229-241
BEECHWOOD AVE
15/10/2024

RESPONSE TO PLANNING COMMENTS (JOHN BERNIER-JUNE 3 -2024)

PREVIOUS ELEVATION AS IDENTIFIED IN THE APPROVED HERITAGE DEMOLITION PERMIT SUBMISSION

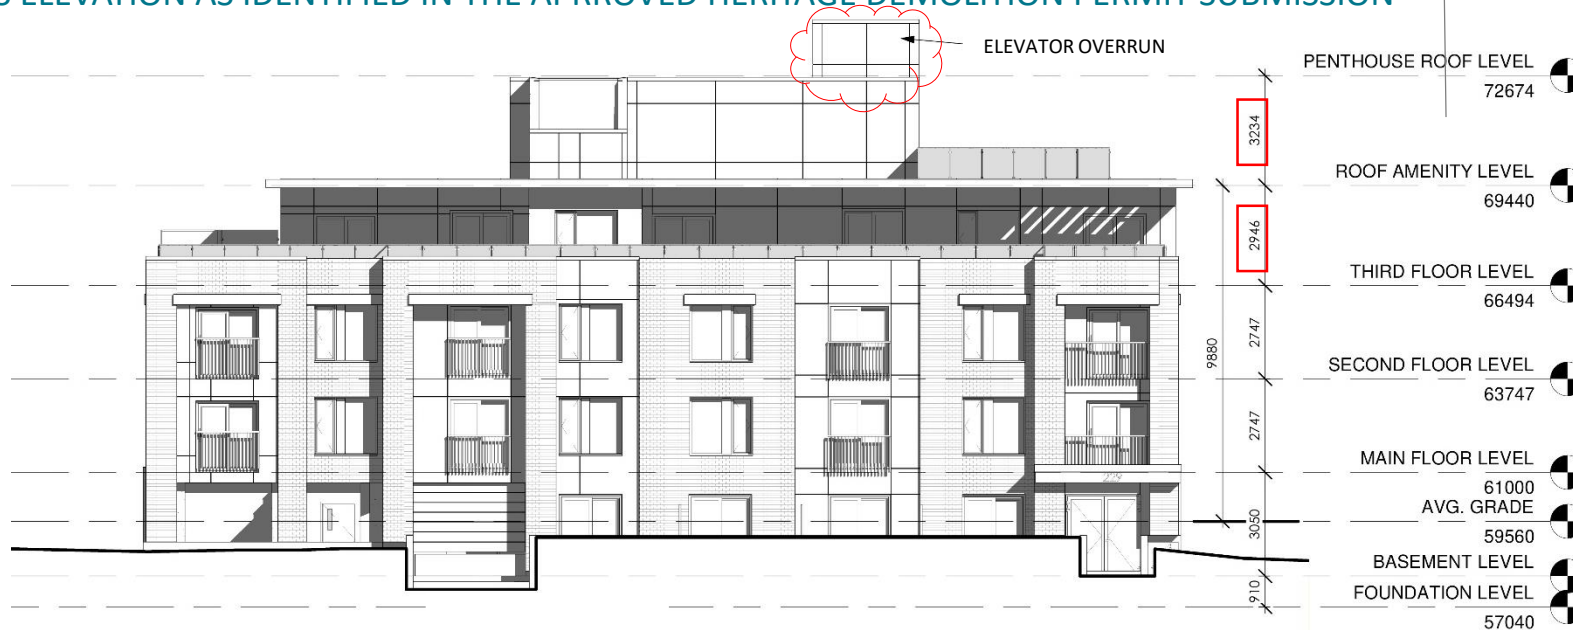
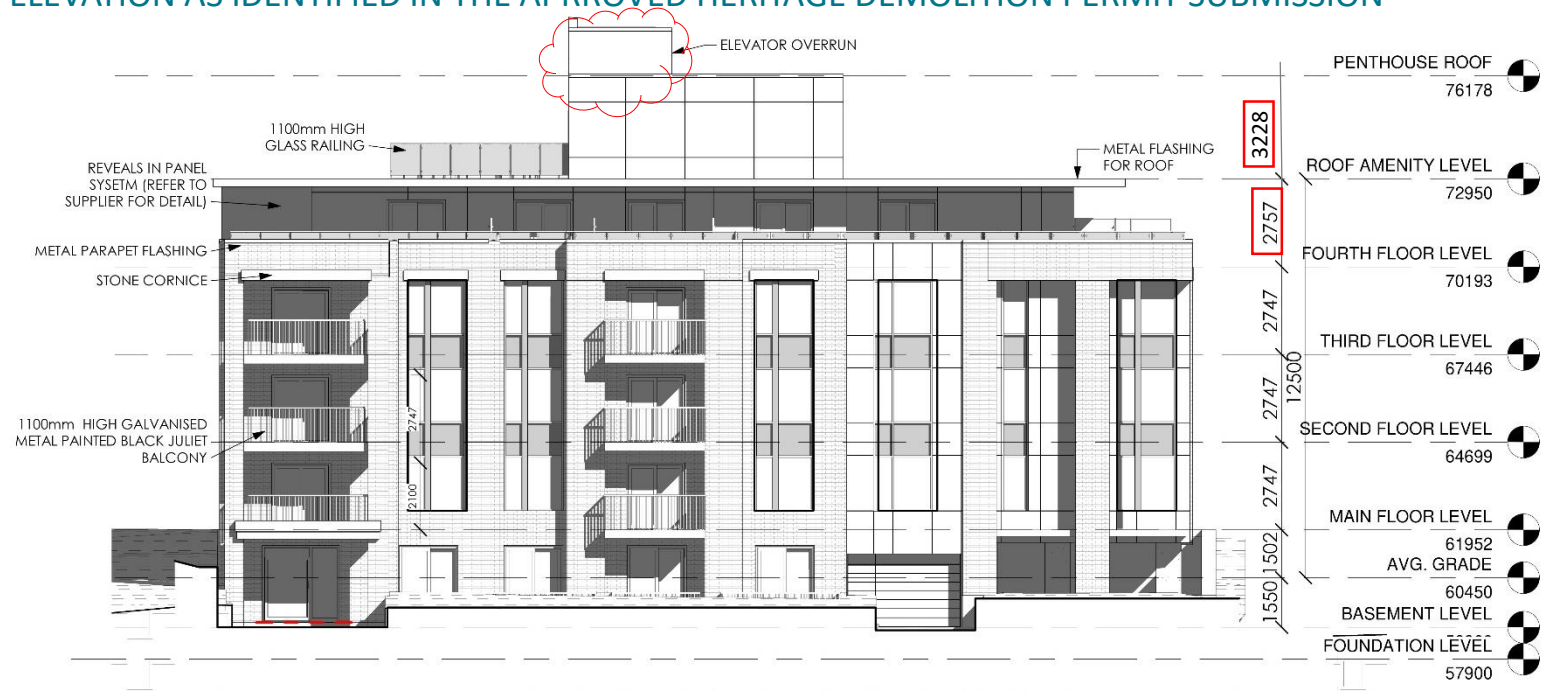
2- The height of the rooftop structure appears to have gotten taller. Can you explain why this is? Reminder that an enclosed amenity space is not a [permitted projection](#).

The height of the rooftop structure has been increased between level 3 and the roof amenity from 2745 mm to 2946 to allow the thickening (including the insulation) of the floor where we have the exterior amenity space.

The height between the Roof amenity level and the penthouse roof level, has been increased from 2745 mm to 3234 mm due to mechanical equipment requirements,

On the new elevations we have included the elevator overrun.

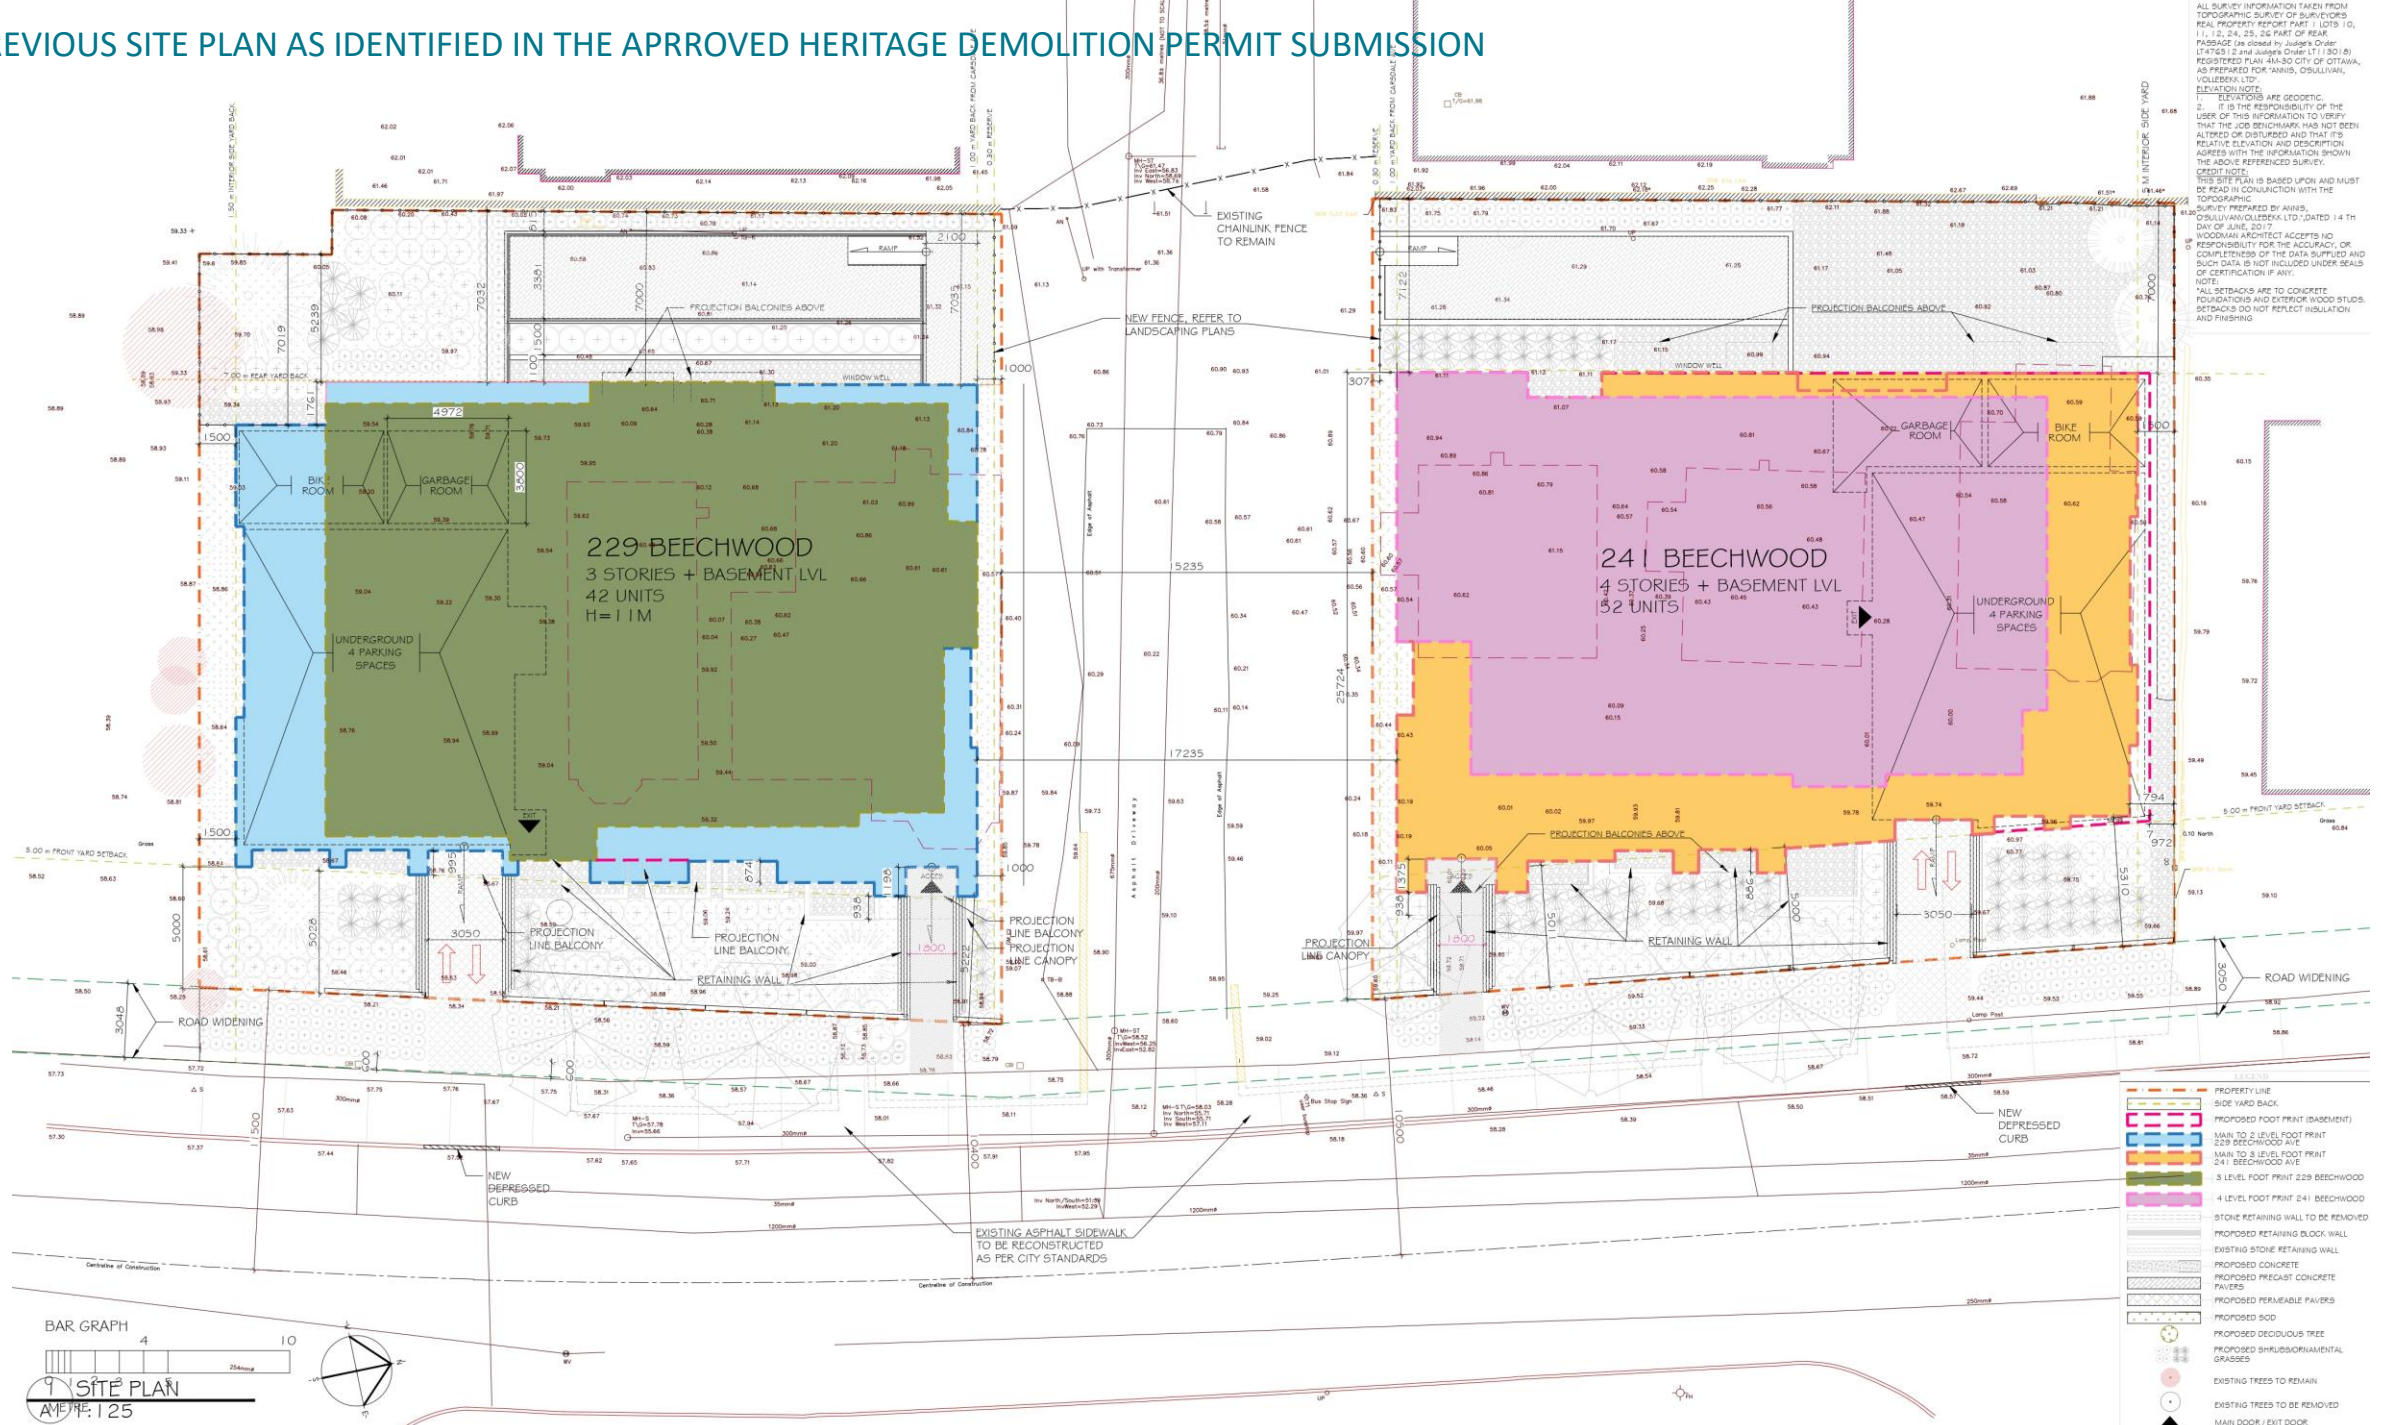
2. Changes to the extent of brick and metal panels throughout both buildings, sizes of windows/design, loss of sills and lintels, colour of the windows/doors (appear to be very light colour, vs chocolate brown)

Please see elevations on page 10, where we tried to match the colors and materials between the previous and the new proposition.

PREVIOUS SITE PLAN AS IDENTIFIED IN THE APPROVED HERITAGE DEMOLITION PERMIT SUBMISSION

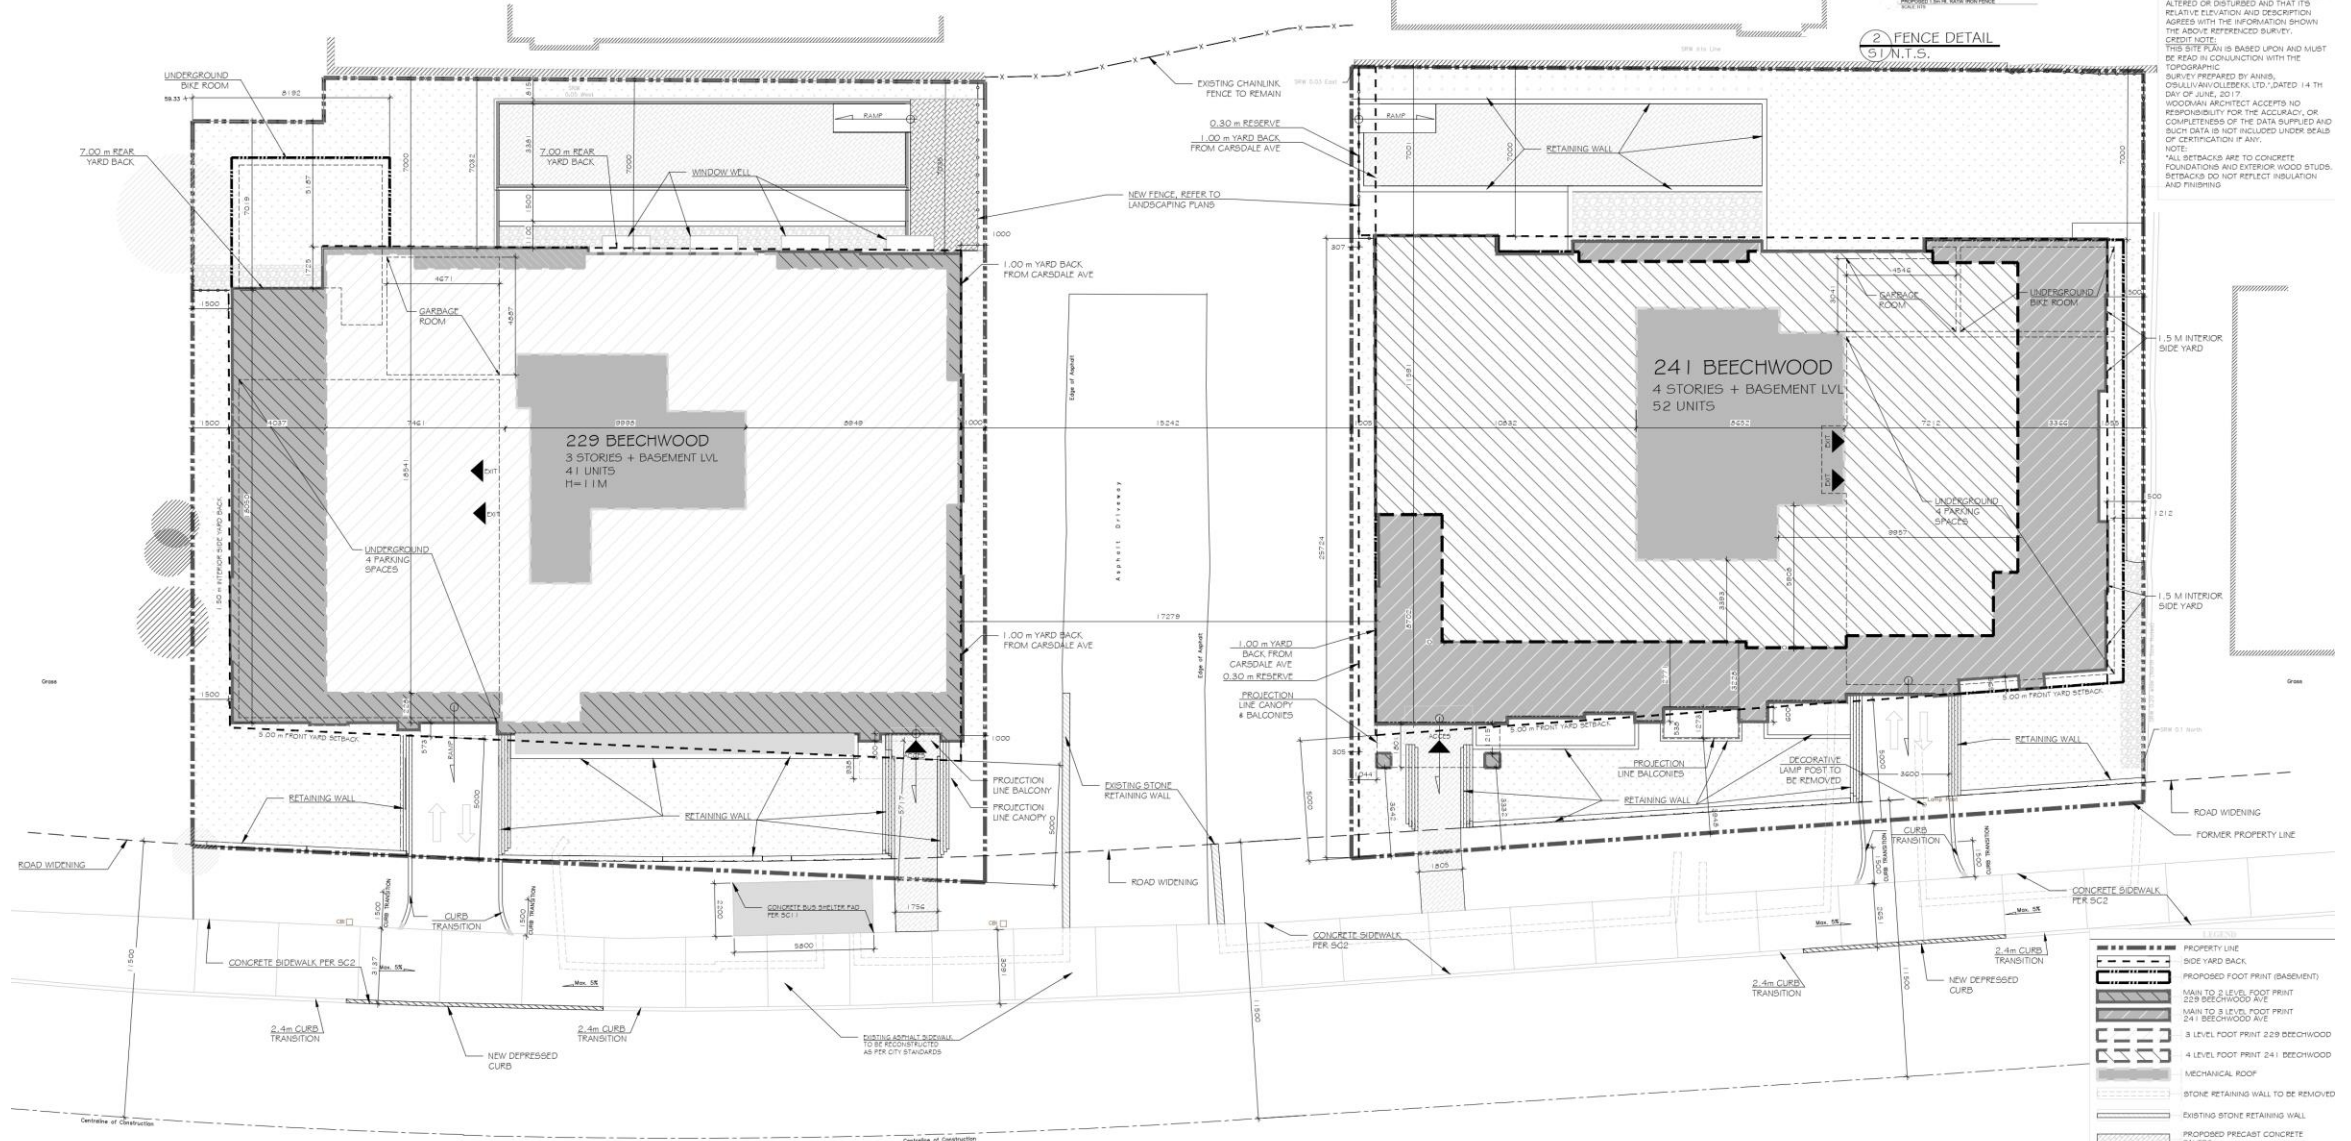
1. 229 Beechwood—the top floor appears to have lost the setback at the rear and north, and it seems to be shallower on the Beechwood façade.
- 2, 241 Beechwood- top floor setbacks appear to have changed as well, at the front in particular, it appears to be shallower than the previous version. Please confirm if this is the case, and if so, please indicate the change on the site plan on page 11 and 12.

We are going back to the original plans submitted for the heritage demolition permit. There are some minor variances on the top floor of the building as you can see on the site plan comparison shown on page 16. This change was made to comply with the minimum area required for some interior spaces and to give a few more areas to the bachelors on 241 Beachwood.
